## **Committee of Experts on the Transport of Dangerous Goods and on the Globally Harmonized System of Classification and Labelling of Chemicals**

#### **Explosives and related matters: review of tests in parts I and II of the Manual of Tests and Criteria**

## **Review of tests in parts I and II of the Manual of Tests and Criteria**

**Transmitted by the Chairman of the Working Group on Explosives**

Figure 11.4.1.1: UN GAP TEST

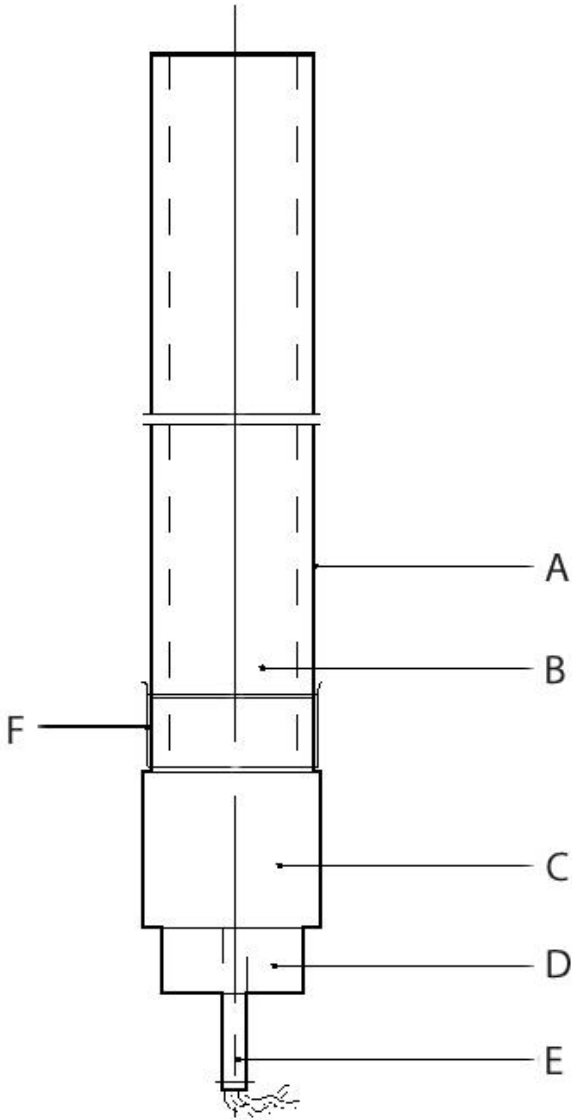
The apparatus for solids is shown in Figure 11.4.1.1. The test sample is contained in a ~~cold-drawn~~, seamless, carbon steel tube with an external diameter of  $48 \pm 2$  mm, a wall thickness of  $4.0 \pm 0.1$  mm and a length of  $400 \pm 5$  mm. If the test substance may react with the steel, the inside of the tube may be coated with fluorocarbon resin. The bottom of the tube is closed with ~~a plastics two layers of 0.08 mm thick polythene~~ sheet pulled tightly (so that it plastically deforms) over the bottom of the tube and held ~~tightly in place with rubber bands and insulating tape. For samples which affect polythene, polytetrafluoroethylene sheet can be used. The plastics sheet shall be compatible with the substance under test.~~ The booster charge consists of 160 g RDX/wax (95/5) or PETN/TNT (50/50),  $50 \pm 1$  mm in diameter with a density of  $1\,600 \pm 50$  kg/m<sup>3</sup> giving a length of about 50 mm. ~~The RDX/wax charges may be pressed in one or more pieces, as long as the total charge is within the specifications, and the PETN/TNT charge is cast. A mild steel witness plate,  $150 \pm 10$  mm square and  $3.2 \pm 0.2$  mm thick, is mounted at the upper end of the steel tube and separated from it by spacers  $1.6 \pm 0.2$  mm thick.~~

The test results are assessed on ~~the basis of the type of~~ fragmentation length of the tube ~~and on whether a hole is punched through the witness plate~~. The test giving the most severe assessment should be used for classification. The test result is considered "+" and the substance to propagate detonation if ~~:-~~

~~\_\_\_\_\_The tube is fragmented completely.:- or~~

~~\_\_\_\_\_A hole is punched through the witness plate.~~

Figure 12.4.1.1: UN GAP TEST

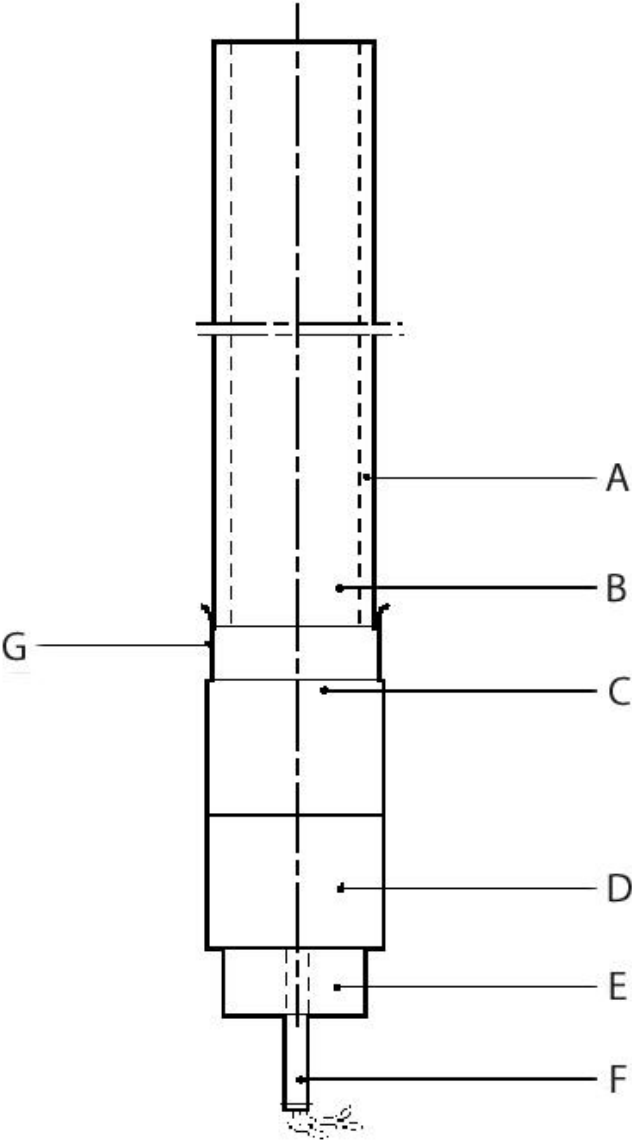
(A) Spacers	(B) Witness plate
(CA) Steel tube	(DB) Substance under investigation
(EC) PMMA spacer	(FD) RDX/wax or PETN/TNT booster charge
(GE) Detonator holder	(HF) Detonator
(JG) Plastics membrane

Figure 21.4.3.1: UN GAP TEST

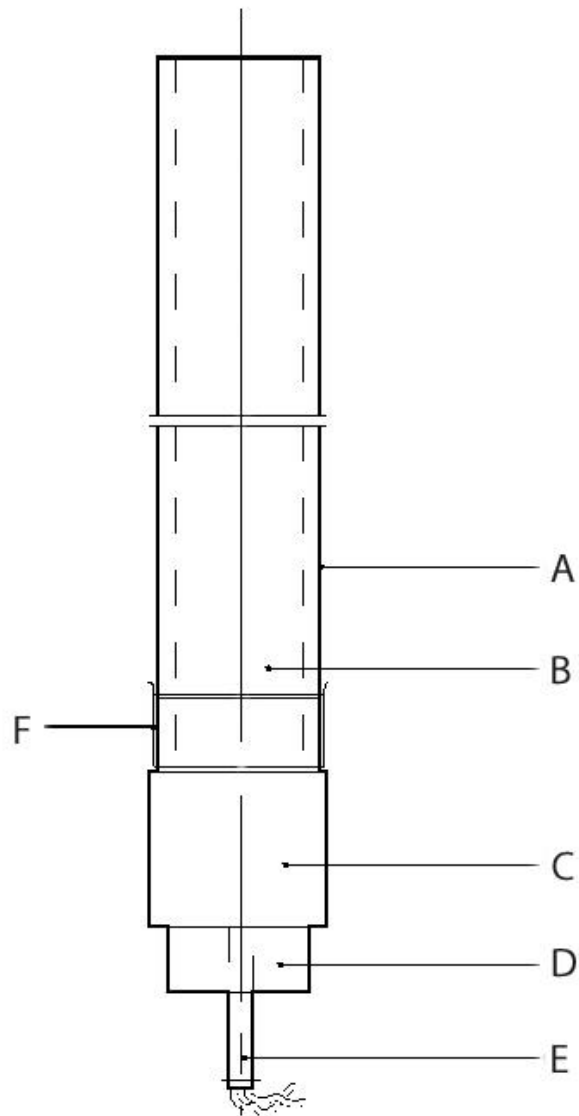
The apparatus is shown in Figure 21.4.3.1. The test sample is contained in an annealed cold-drawn, seamless, carbon steel tube with an external diameter of  $48 \pm 2$  mm, a wall thickness of  $4.0 \pm 0.1$  mm and a length of  $400 \pm 5$  mm. If the test substance may react with the steel, the inside of the tube may be coated with fluorocarbon resin. The bottom of the tube is closed with a plastics two layers of 0.08 mm thick polythene sheet pulled tightly (so that it plastically deforms) over the bottom of the tube and held tightly in place ~~with rubber bands and insulating tape~~. ~~For samples which affect polythene, polytetrafluoroethylene sheet can be used.~~ The plastics sheet shall be compatible with the substance under test. The booster charge consists of 160 g RDX/wax (95/5) or PETN/TNT (50/50),  $50 \pm 1$  mm in diameter with a density of  $1\,600 \pm 50$  kg/m<sup>3</sup> giving a length of about 50 mm. ~~The RDX/wax charges may be pressed in one or more pieces, as long as the total charge is within the specifications, and the PETN/TNT charge is cast. A mild steel witness plate,  $150 \pm 10$  mm square and  $3.2 \pm 0.2$  mm thick, is mounted at the upper end of the steel tube and separated from it by spacers  $1.6 \pm 0.2$  mm thick.~~

21.4.3.4.1 The test results are assessed on the basis of the fragmentation pattern of the tube. ~~The witness plate is used only to provide supplemental information on the violence of the reaction.~~ The test giving the most severe assessment should be used for classification.

Figure 21.4.4.1: UN DETONATION TEST

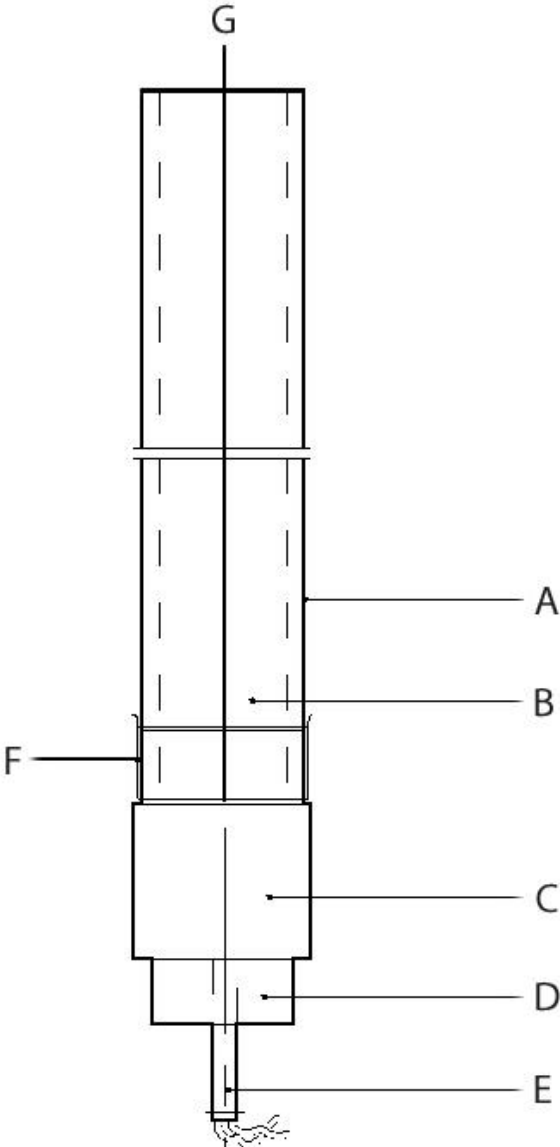
The apparatus is shown in Figure 21.4.4.1 and is identical for solids and liquids. The test sample is contained in ~~an annealed cold drawn~~, seamless, carbon steel tube with an external diameter of  $60 \pm 1$  mm, a wall thickness of  $5 \pm 1$  mm and a length of  $500 \pm 5$  mm. If the test substance may react with the steel, the inside of the tube may be coated with fluorocarbon resin. The bottom of the tube is closed with a plastics two layers of 0.08 mm thick polythene sheet held tightly in place with rubber bands and insulating tape. For samples which affect polythene, polytetrafluoroethylene sheet can be used. The plastics sheet shall be compatible with the substance under test. The booster charge is a 200 g RDX/wax (95/5) or PETN/TNT (50/50),  $60 \pm 1$  mm in diameter and about 45 mm long with a density of  $1\,600 \pm 50$  kg/m<sup>3</sup>. The ~~RDX/wax charges~~ may be pressed in one or more pieces as long as the total charge is within the specifications ~~and the PETN/TNT charge is cast~~. The tube may be instrumented, e.g. by a continuous wire velocity probe, to measure the velocity of propagation in the substance. ~~Additional information on the explosive behaviour of the test sample can be gained by the use of a witness plate, as shown in Figure 21.4.4.1. The mild steel witness plate, 150 mm square and 3.2 mm thick, is mounted at the upper end of the tube and separated from it by spacers 1.6 mm thick.~~

| (CA) Steel tube                         | (DB) Substance under test |
| (EC) RDX/wax or PETN/TNT booster charge | (FD) Detonator holder     |
| (GE) Detonator                          | (HF) Plastics sheet       |
| (G) Velocity probe (optional)           |                           |

Figure 23.4.1.4: IGNITION SYSTEM FOR LIQUIDS

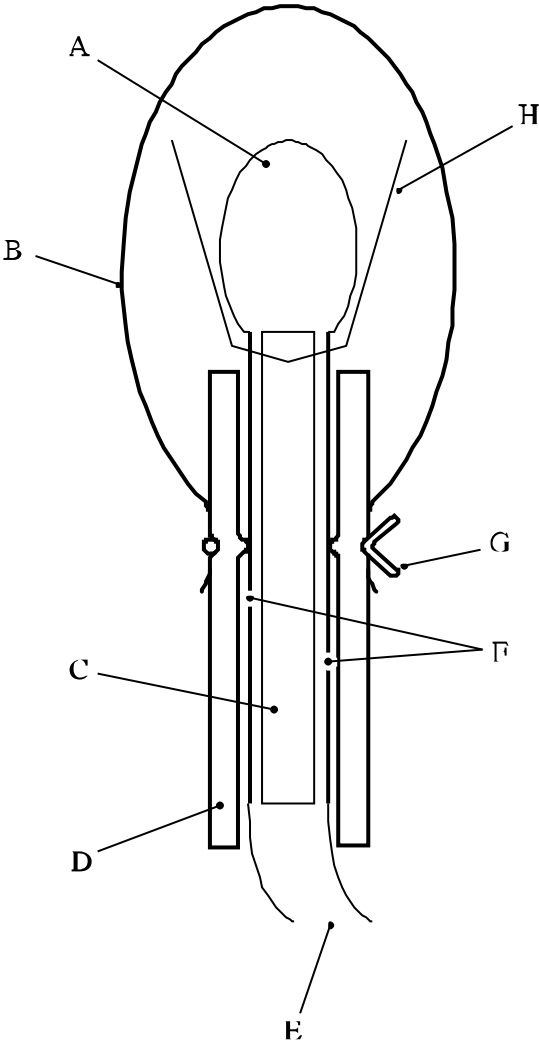
23.4.1.2.7 For liquids samples, ~~leads are fixed onto the contact foils of the fusehead. The leads are then threaded through an 8 mm length of 5 mm outer diameter and 1 mm inner diameter silicone rubber tubing~~

~~and the tubing is pushed up over the fusehead contact foils as shown in Figure 23.4.1.4. The primed cambric is then wrapped around the fusehead and~~ a single piece of thin PVC sheathing, or equivalent, is used to cover the primed cambric in such a way that the primed cambric is not in contact with the liquid sample. and the silicone rubber tubing. The sheathing is sealed in position by twisting a length of thin wire tightly round the sheathing and rubber tubing. The leads of the resistance wire are then fixed onto the terminals of the firing plug such that the tip of the fusehead-primed cambric is ~~13 mm~~ above the surface of the firing plug.
